April 12, 2021 Case #2021-214

Request: Conditional Use and site plan request for an indoor golf facility.

Hudson Planning Commission	SITE PLAN REVIEW
Case No. 2021-214, 2019	April 12, 2021

UTILITY PLAN

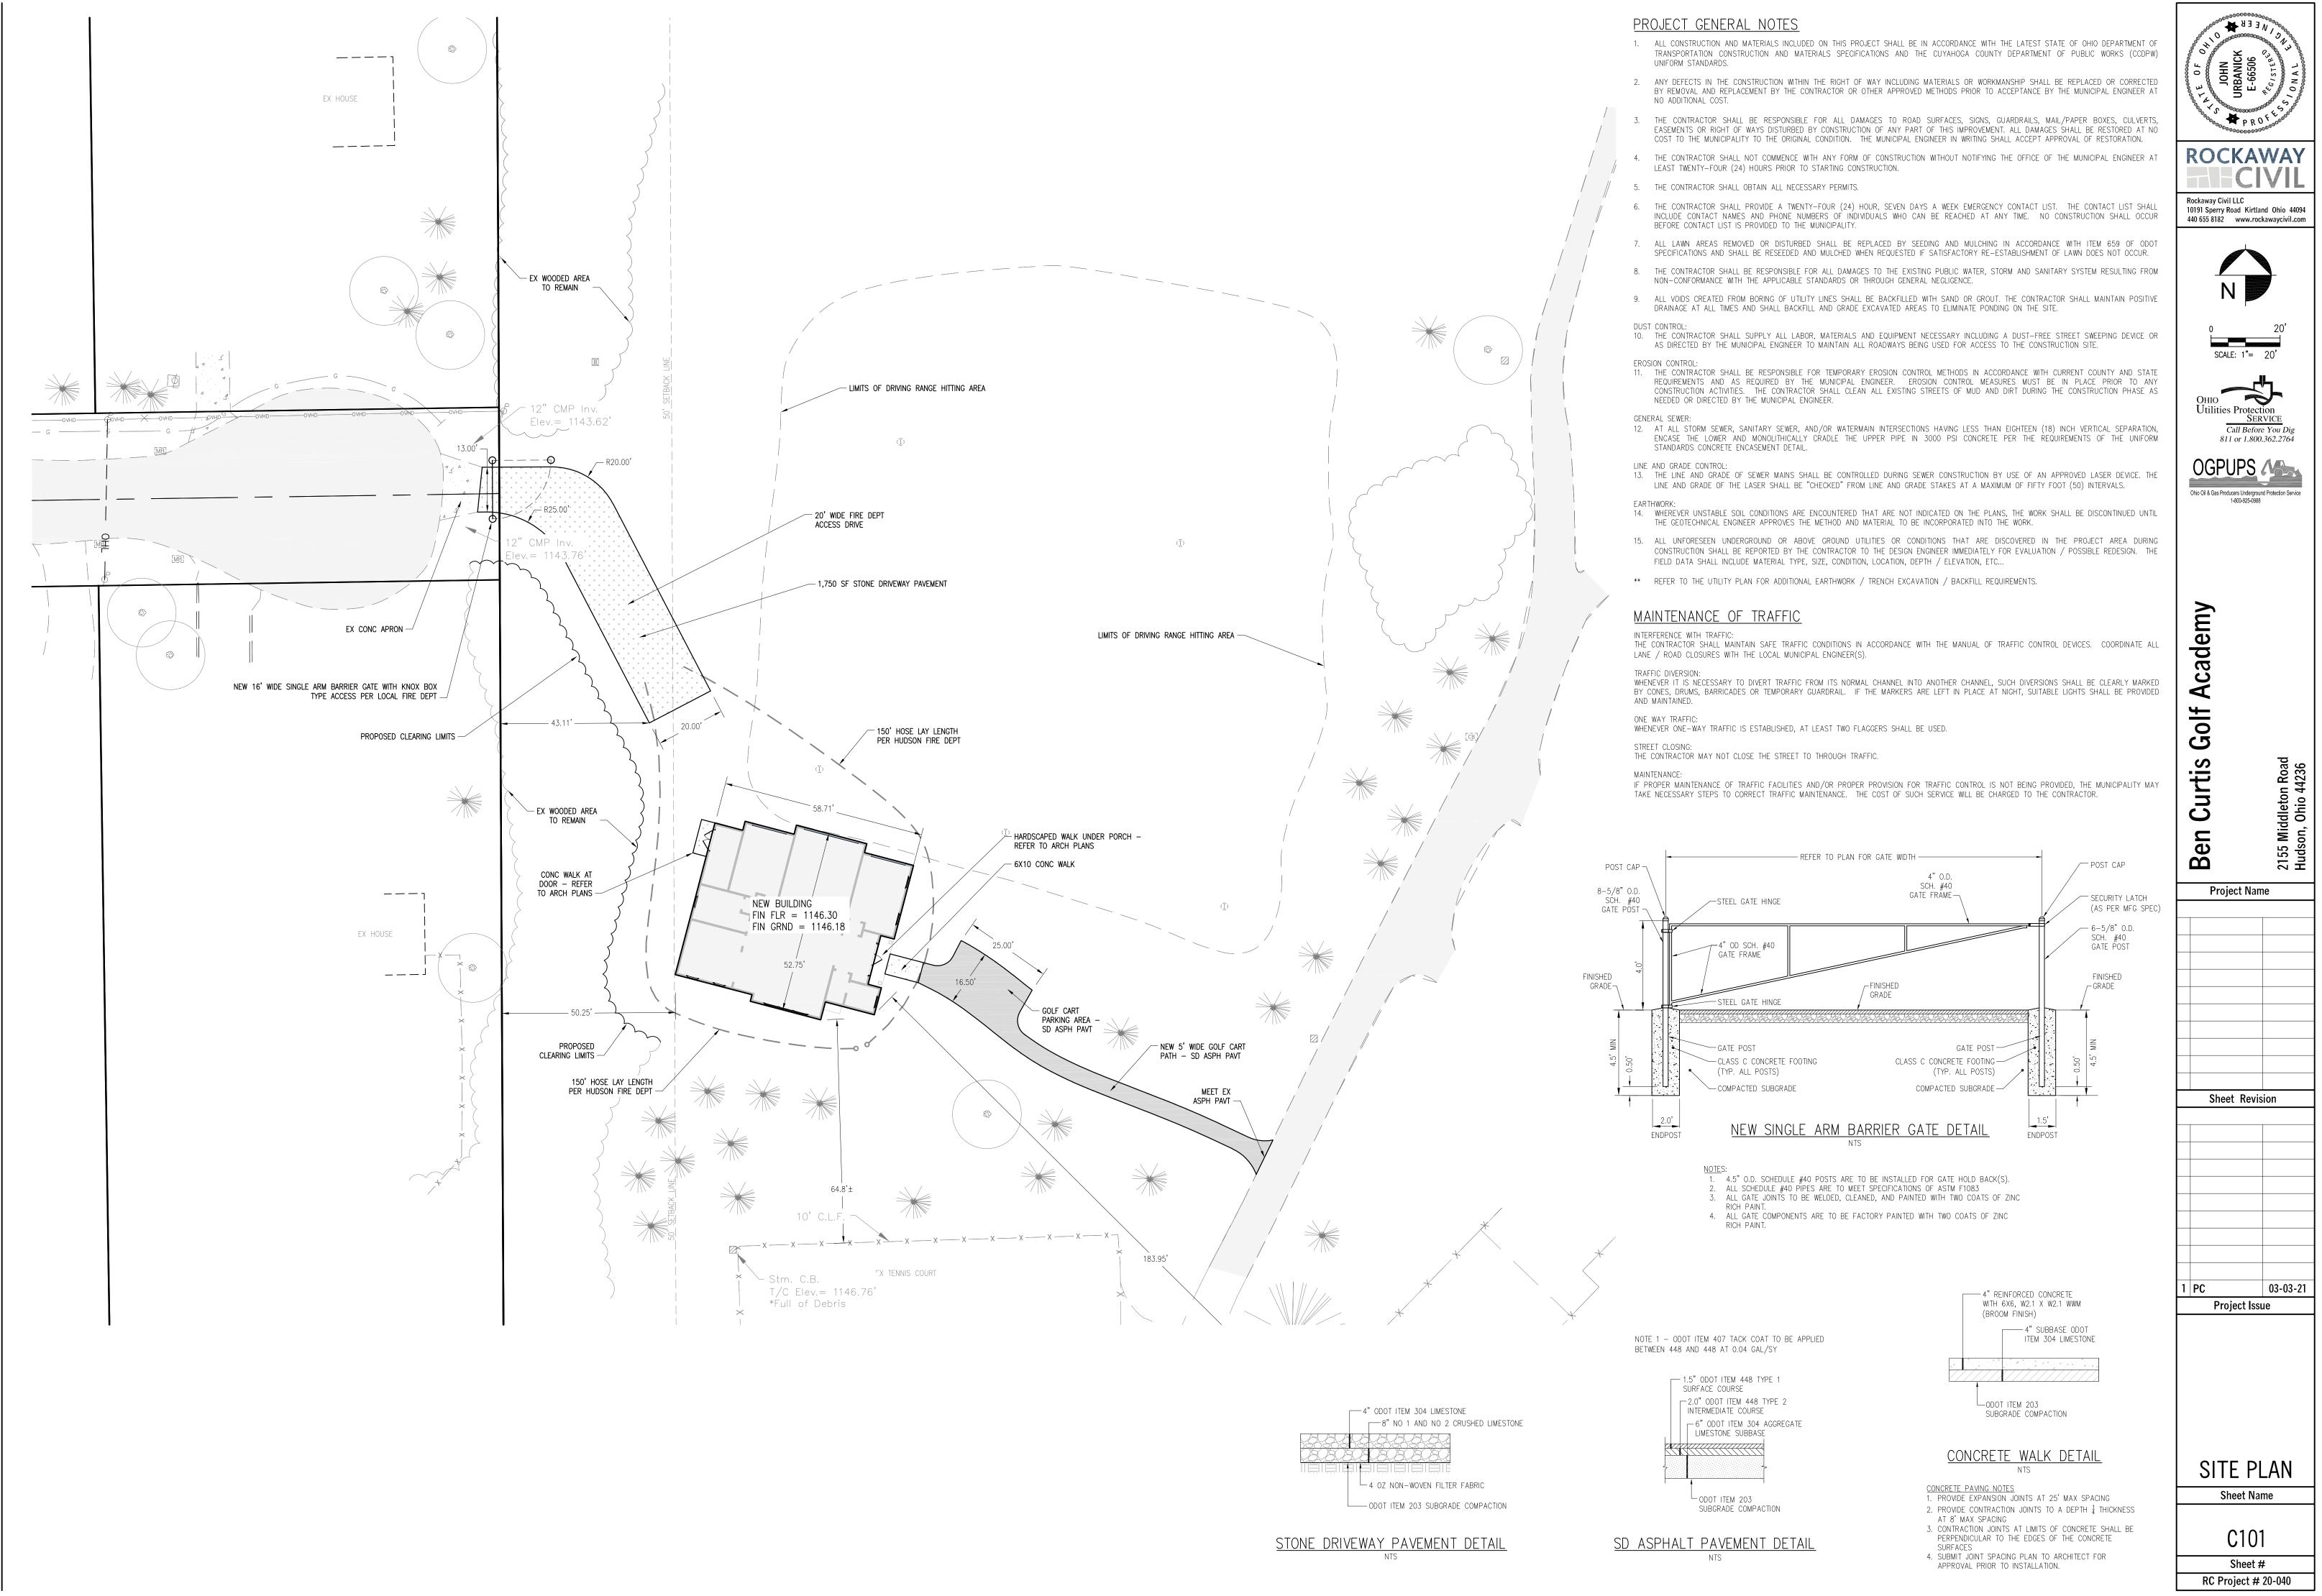
- **Sewer** Summit County DOSSS: A sewer line currently extends across the existing drive range to the north of the proposed building. The proposal would extend a line approximately one hundred (100) feet across the driving range to the training facility.
- **Water** Private: A private well system serves the property. The building would be tied into an existing well located approximately two hundred (200) feet to the south near the swimming pool clubhouse.

FIRST FLOOR PLAN

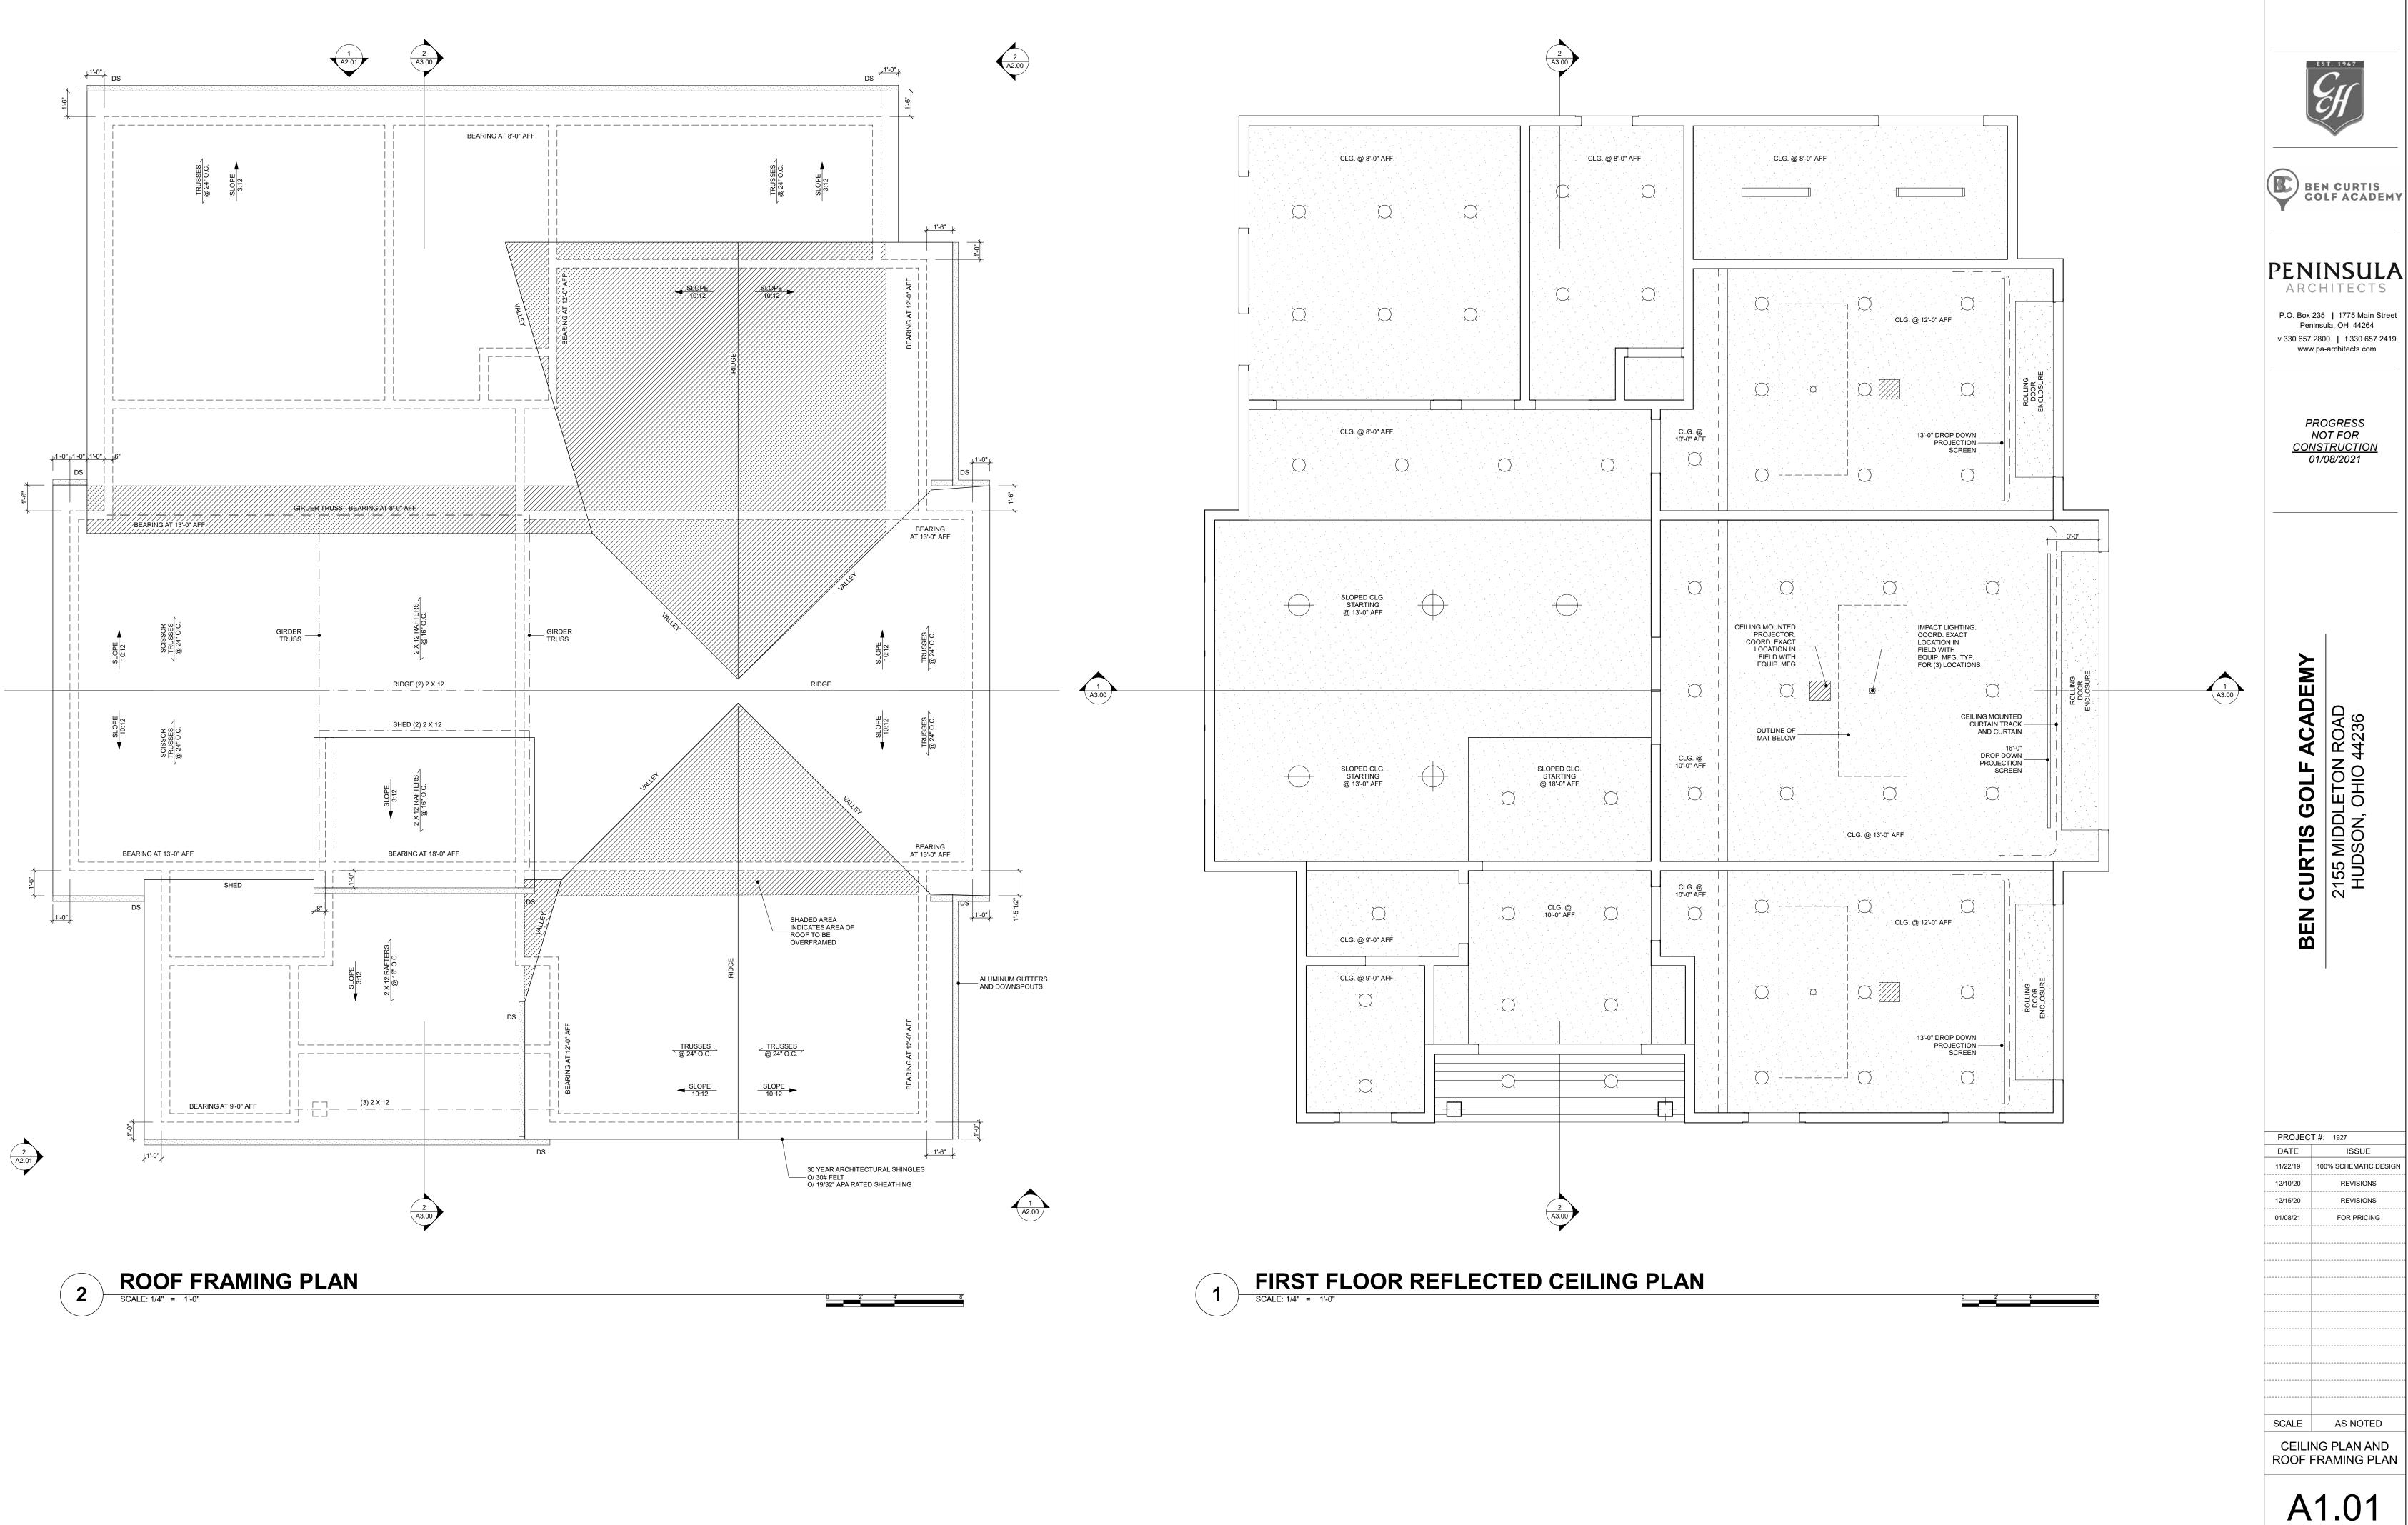
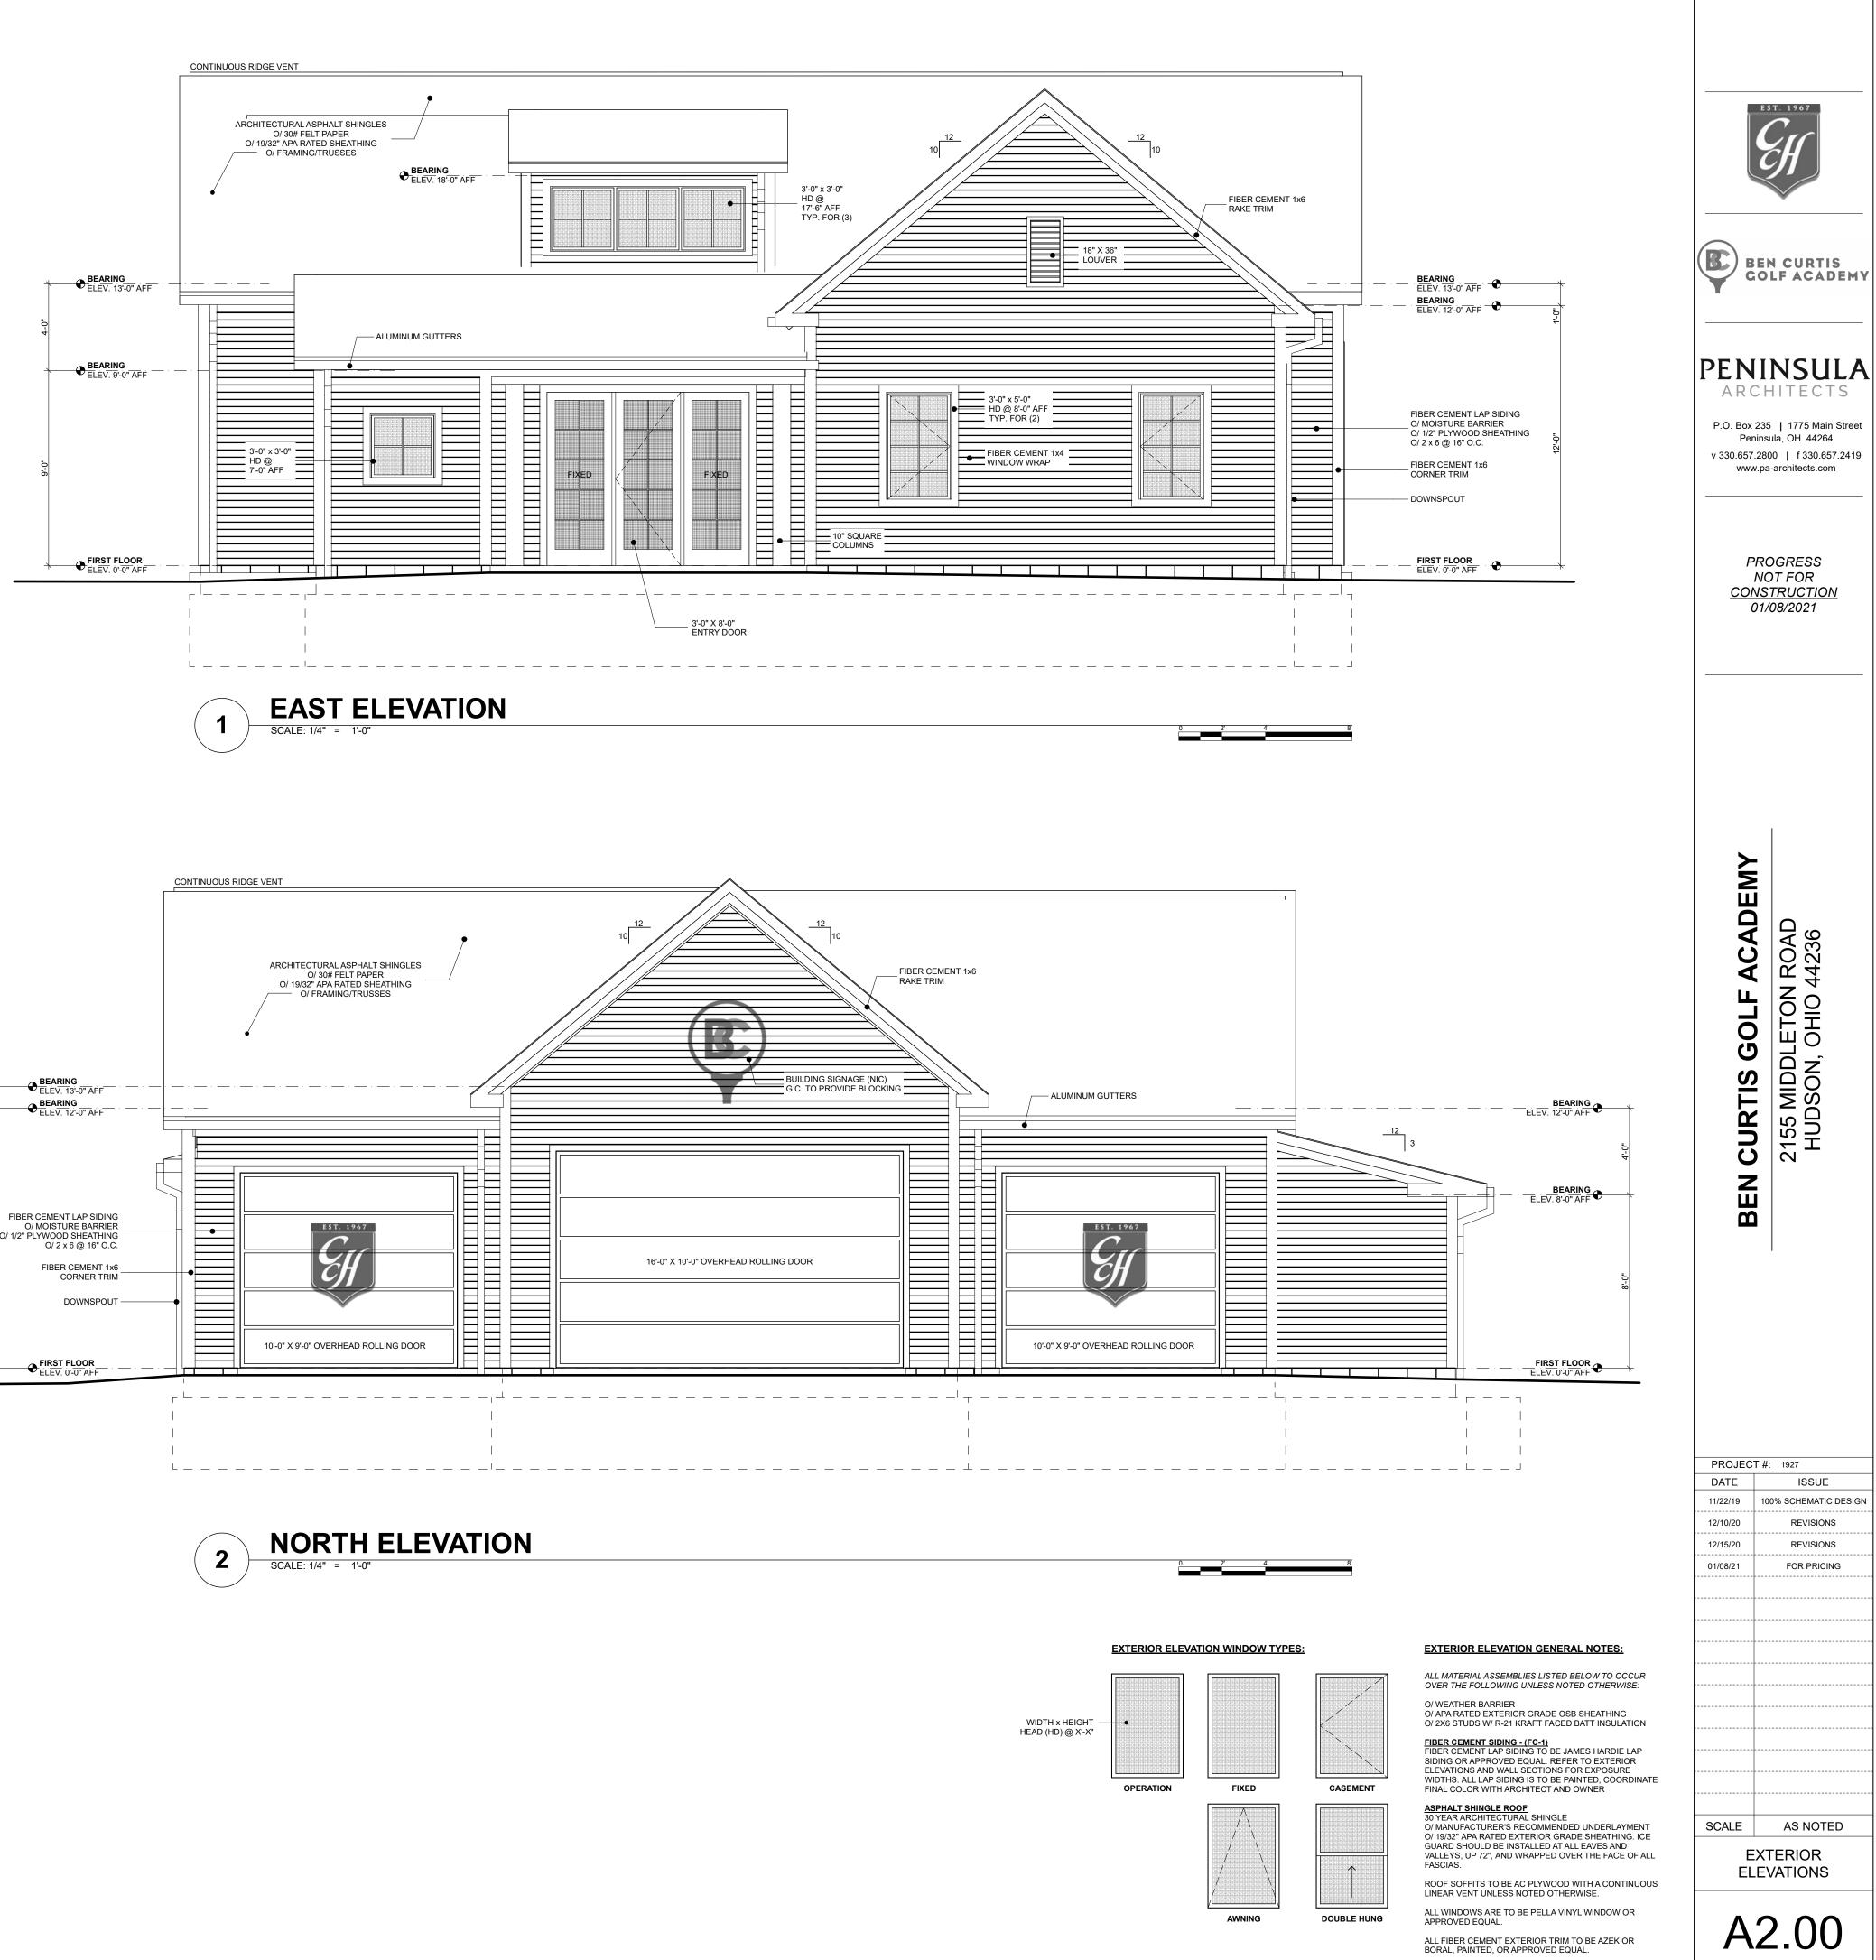
- Noise: The facility has been described by the applicant as an indoor golf training facility, however; staff notes three overhead doors proposed on the north wall. These doors would lead out to the existing driving range from the proposed training bays. Question how these doors would be utilized with the overall operation of the facility. Additionally, staff suggests relocating the equipment doors to the north elevation to minimize impact on adjacent residential uses. Finally, outdoor speakers/music should be prohibited due to the proximity of the building near Garden Lane.

- 6. Outdoor speakers/music shall be prohibited.
- 7. Equipment room doors shall be relocated to the north elevation.
- 8. Construction activity including staging area, waste container area, and concrete washout be located a minimum twenty-five (25) feet from the western property boundary.
